Subject: **PSEG Early Site Permit Application**  
**Docket No. 52-043**  
**Response to Request for Additional Information, RAI No. 2, Emergency Plan**  
**Evacuation Time Estimate**

References: 1) PSEG Power, LLC letter to USNRC, Application for Early Site Permit for the PSEG Site, dated May 25, 2010  
2) RAI No. 2, Emergency Plan Evacuation Time Estimate, dated January 4, 2011 (eRAI 5207)

**PSEG Letter to USNRC, ND-2011-0002**

**RESPONSE to RAI No. 2**

**Figure 1 - Olde Tyme Peach Festival Parade Route Map**

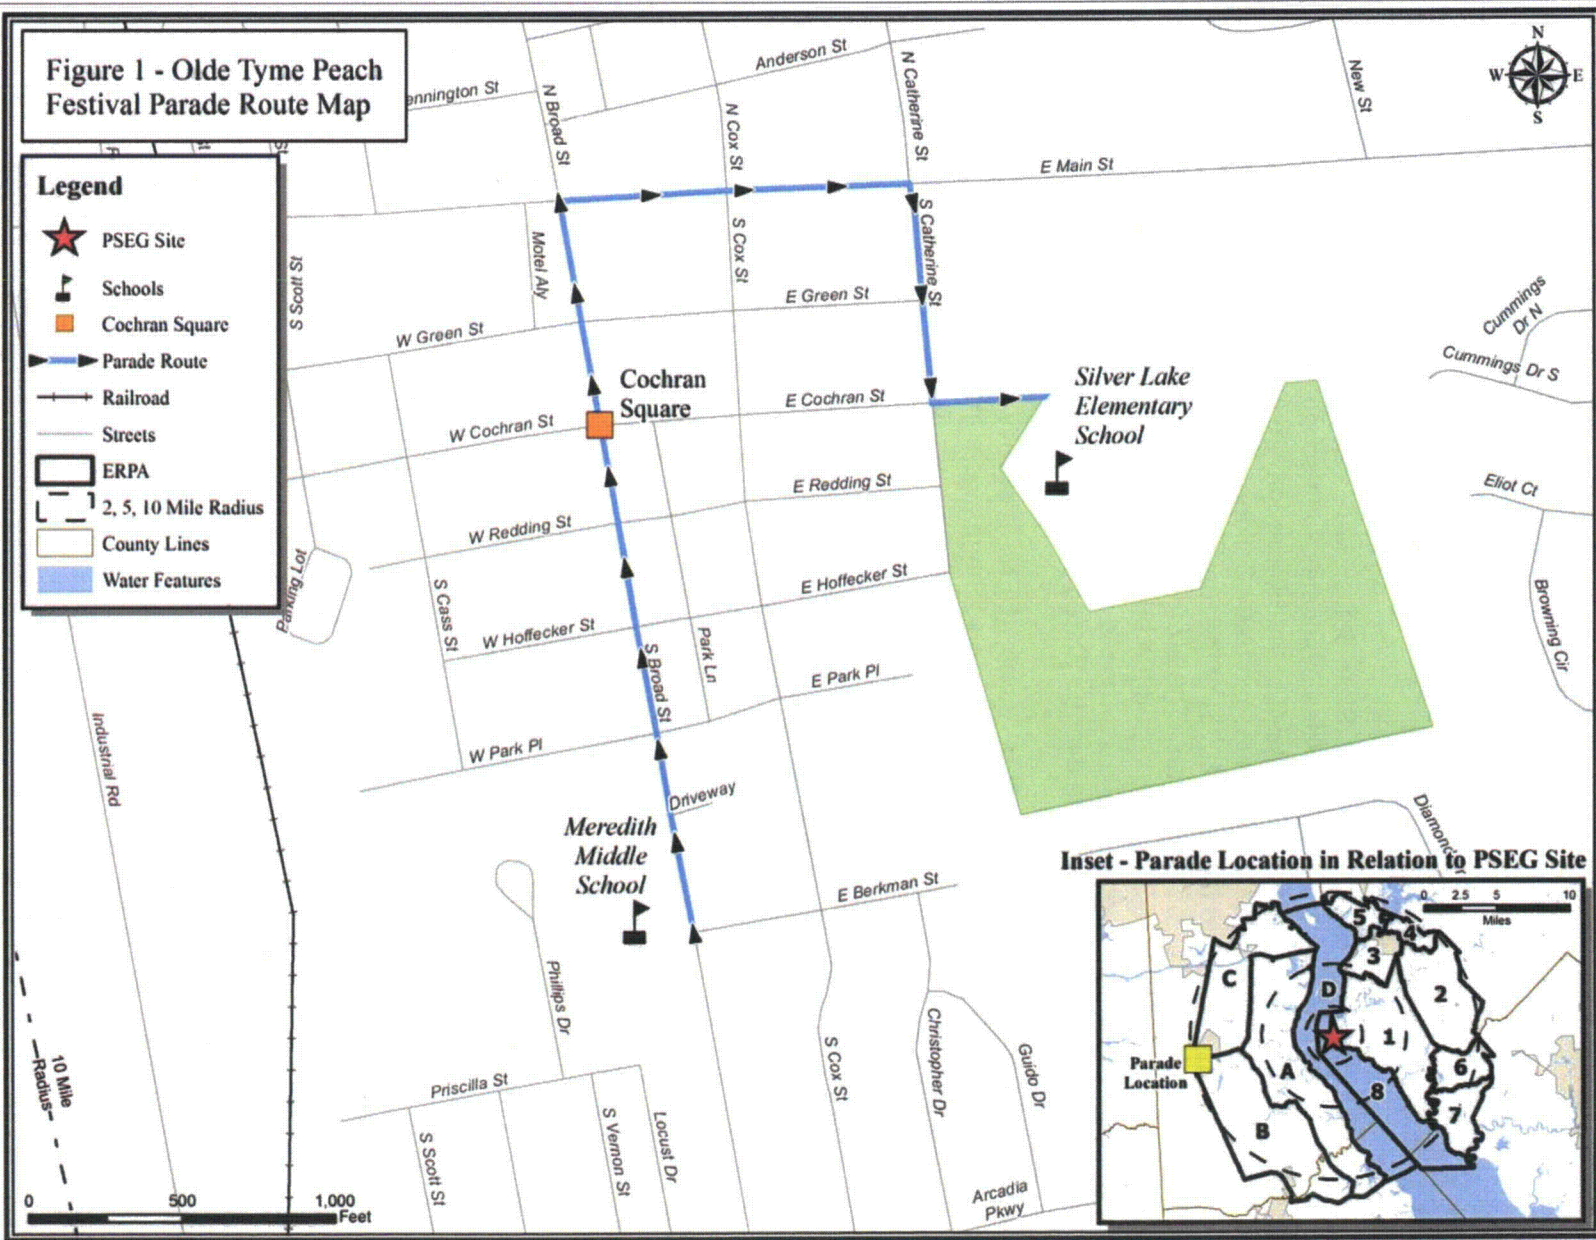
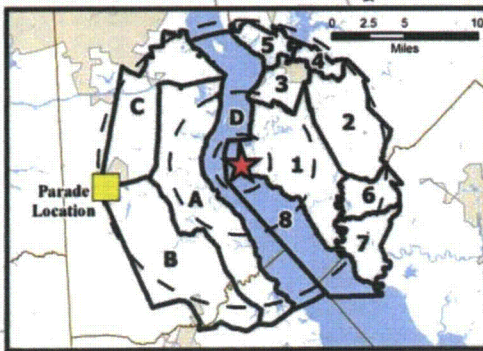
*The annual Olde Tyme Peach Festival in Middletown, Delaware brings 27,000 people into the town for the one day event. Explain whether this festival should be added as a special event within the EPZ, and include the analysis in the ETE Report, if appropriate.*

The festival is held each year on a Saturday in August. According to the website for the Middletown Historical Society (<http://middletownde-hist.org/node/32>), there is a parade from 9:00am to 10:00am followed by the festival from 10:00am to 4:00pm. The parade starts at Meredith Middle School on Broad St, proceeds north on Broad St to Cochran Square for performances, then proceeds north to Main St, east on Main St to Catherine St, and then south on Catherine St to Silver Lake School, where the parade disbands. The roads along the parade route are closed for the duration of the parade. See Attachment 13.03-3-A for a map of the parade route and the location of the parade relative to the proposed PSEG site.

There is congestion expected in Middletown during evacuation, as discussed in Section 7.2 of the ETE report. The parade closes portions of the two major routes (Main St and Broad St) servicing evacuees from Middletown, making it prudent to consider a sensitivity study for the Olde Tyme Peach Festival.

The annual Olde Tyme Peach Festival in Middletown, Delaware attracts 2,500 additional transients into the EPZ during peak times. A sensitivity study was conducted, and it was found that the ETE are not affected by this event.

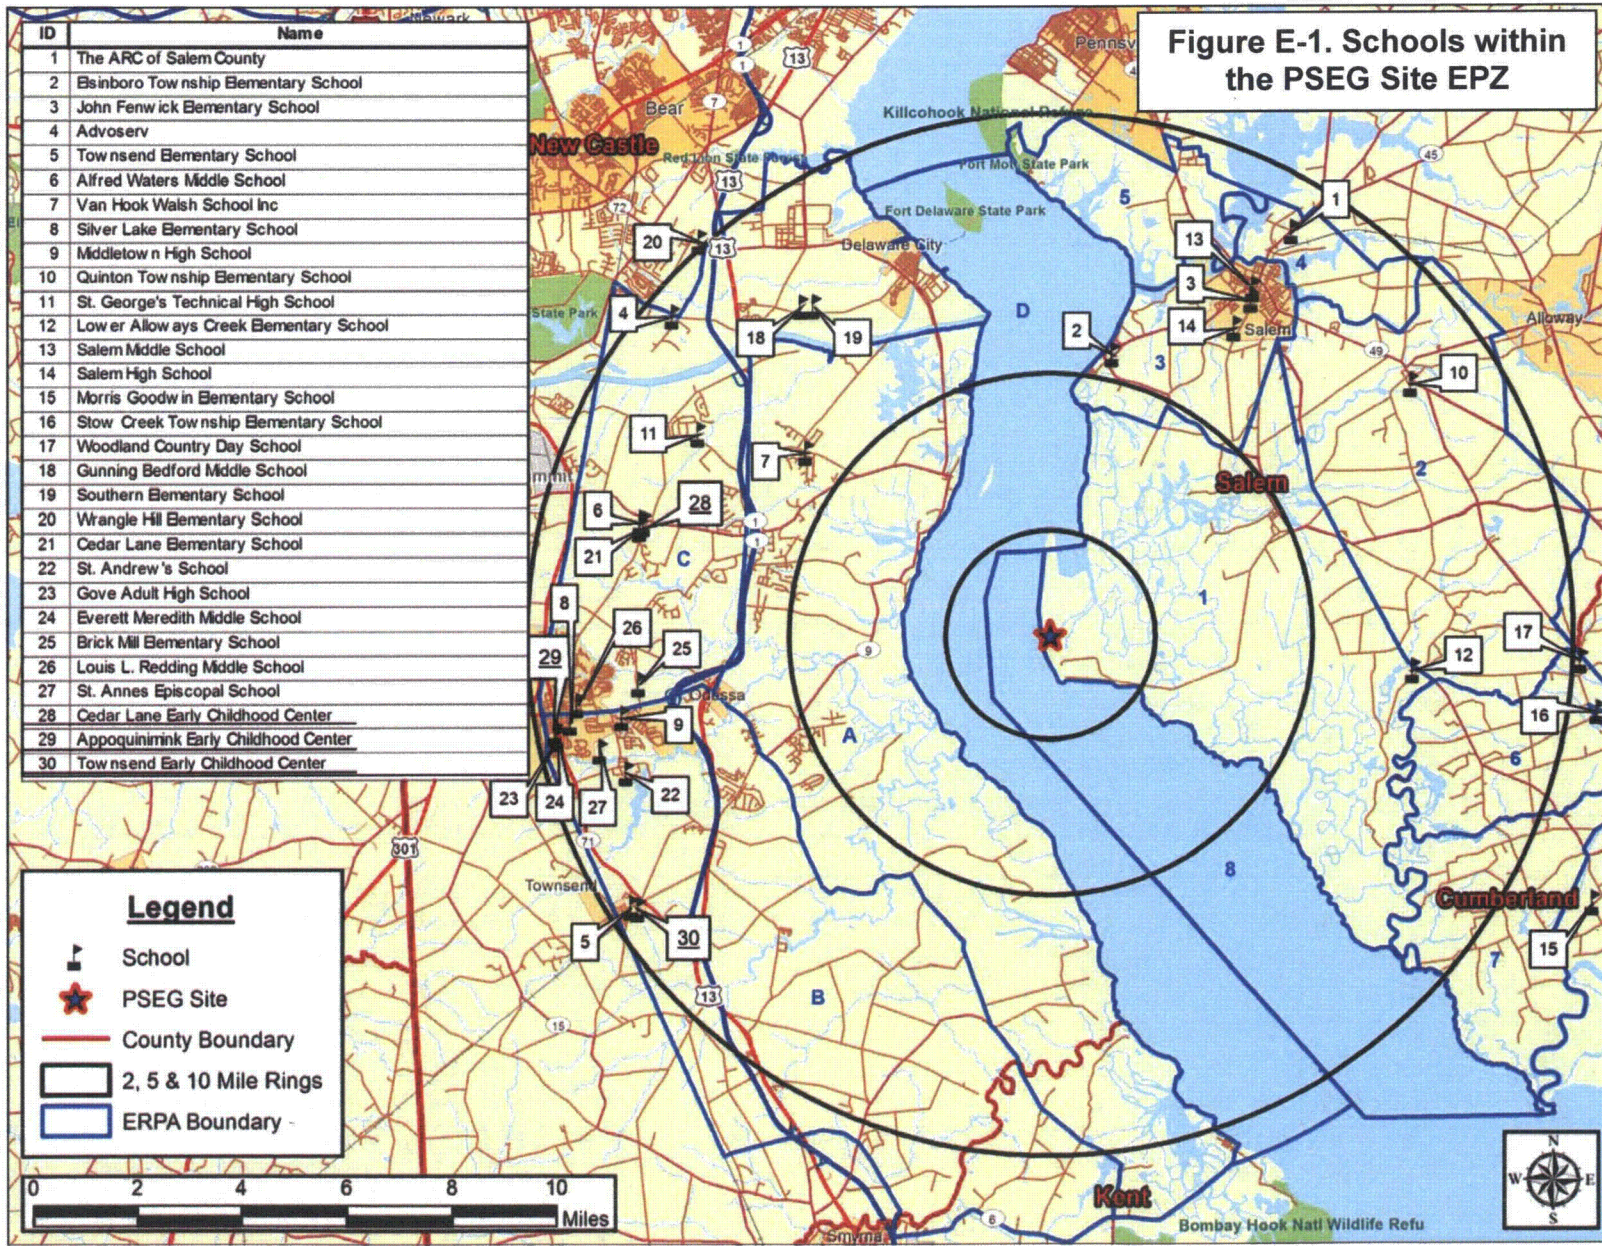
*Table 8-2, "School Population Demand Estimate," lists 15,059 students which includes all of the schools identified in Table E-1, "Schools within the PSEG Site EPZ," and some of the schools from Table E-2, "Day Care Facilities within the PSEG Site EPZ." Explain in the ETE Report why only some of the Table E-2 schools were included in the analysis.*

5. Table E-1 will be revised in a future revision of the ETE report to add Appoquinimink Early Childhood Center, Townsend Early Childhood Center and Cedar Lane Early Childhood Center to the New Castle, DE Schools.

7. Figure E-1 will be revised in a future revision of the ETE report to add Appoquinimink Early Childhood Center, Townsend Early Childhood Center and Cedar Lane Early Childhood Center.
